**OXFORDSHIRE COUNTY COUNCIL RESPONSE  
ON WATER RESOURCES CONSULTATION  
DRAFT REGIONAL PLAN FOR THE WEST  
Consultation closing date: 20<sup>th</sup> February 2023**

Figure 1: Map of Grand Union Canal Transfer<sup>3</sup>

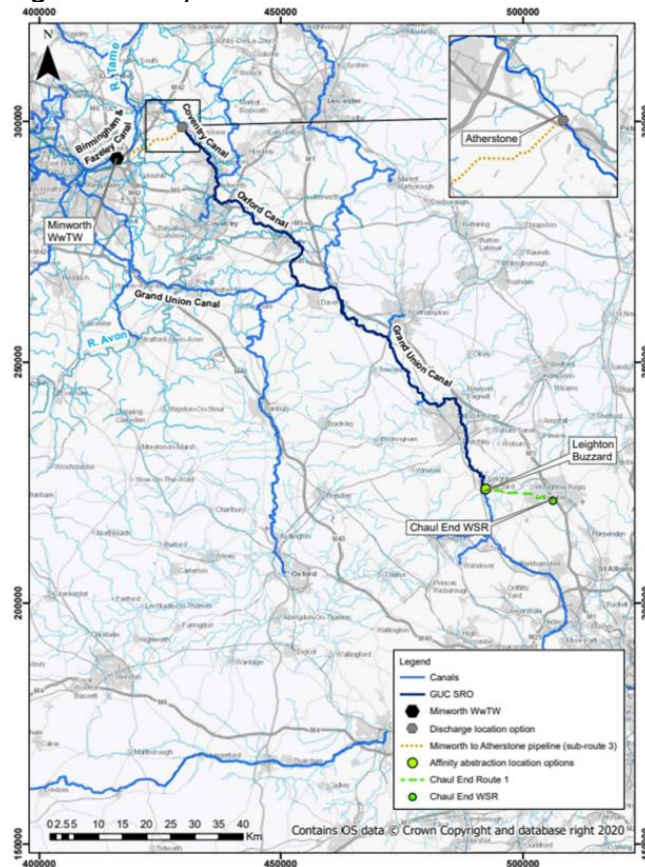
5. The GUC scheme now involves transferring water from Minworth wastewater treatment works in the West via the Coventry Canal, Oxford Canal and Grand Union Canal to Affinity Water in the South East, supplying Affinity Water customers with up to 50MI/d from 2031 and a further 50MI/day by 2040 to 2050.

7. Elements of the Grand Union Canal would be upgraded as part of this, for example increasing canal bank and towpath levels at certain locations, and there would be new pipeline connections at either end.

8. The option sensibly uses an existing canal resource to get water from the Midlands to London. It is understood that the option is supported by the Canal & River Trust and there would be benefits from upgraded facilities, flood alleviation, habitat creation etc.

9. The proposed location at the southern end in Hertfordshire is Leighton Buzzard where there would be new abstraction and treatment facilities.
10. Severn Trent Water and Affinity Water are jointly promoting this water supply option. The route does not go through Oxfordshire. It enables Affinity Water to have a different new source of water than that from a pipeline from the River Thames i.e. the Thames to Affinity Transfer.

11. Given that the source of the water is to be treated wastewater from the Minworth Waste Water Treatment Works, it is an option which is resilient to drought because wastewater is produced and fed into the Works under all conditions.

12. Oxfordshire County Council supports the GUC proposal.

Figure 5: Map showing STT elements<sup>7</sup>

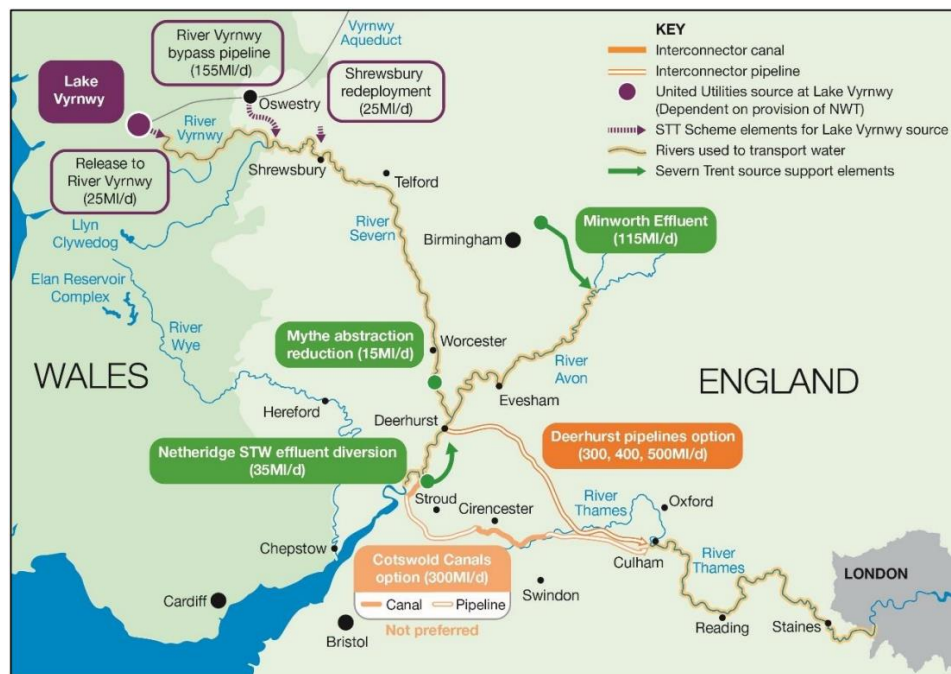
17. Figure 5 is the map from the RAPID gate 2 submission which shows the amounts in Figure 4. It also shows the route options for STT: a new pipeline (from Deerhurst in Gloucestershire to Culham in Oxfordshire which could provide for up to 500 MI/d); or to reinstate parts of the Cotswold Canals and augment that with pipelines (from Gloucester Dock to Culham which could provide for up to 300 MI/d). The draft WRSE and WRW regional plans indicate that it is the 500 MI/d pipeline Deerhurst to Culham which is preferred. Oxfordshire County Council is concerned that the preferred position is a missed opportunity as the alternative route using the Cotswold Canals utilises existing infrastructure and could help support the upgrading of the canals. Although theoretically the pipeline option provides much more capacity than the canals by enabling a transfer of 500 MI/d, the pipeline is stated in the November 2022 RAPID Gate 2 main report as enabling only a deployable output of up to 354 MI/d on average, which is not much more than the Cotswolds Canals option of up to 300 MI/d.

18. The STT includes water treatment works at the intake locations to mitigate potential impacts on water quality or from invasive species on the River Thames. A discharge outfall structure would need to be constructed within the banks of the River Thames at Culham in Oxfordshire.

25. Oxfordshire County Council noted in our response to the emerging WRSE regional plan early in 2022 that there are some environmental concerns with the STT pipeline. However, overall, such a pipeline would better meet policies about bringing in water to the South East and preferring underground infrastructure to a complex banded reservoir such as SESRO.

27. Oxfordshire County Council would support provision to bring forward STT earlier and provided for additional amounts of water to be transferred.
28. The WRW regional plan should be amended from the draft to more clearly provide for STT at an earlier date.
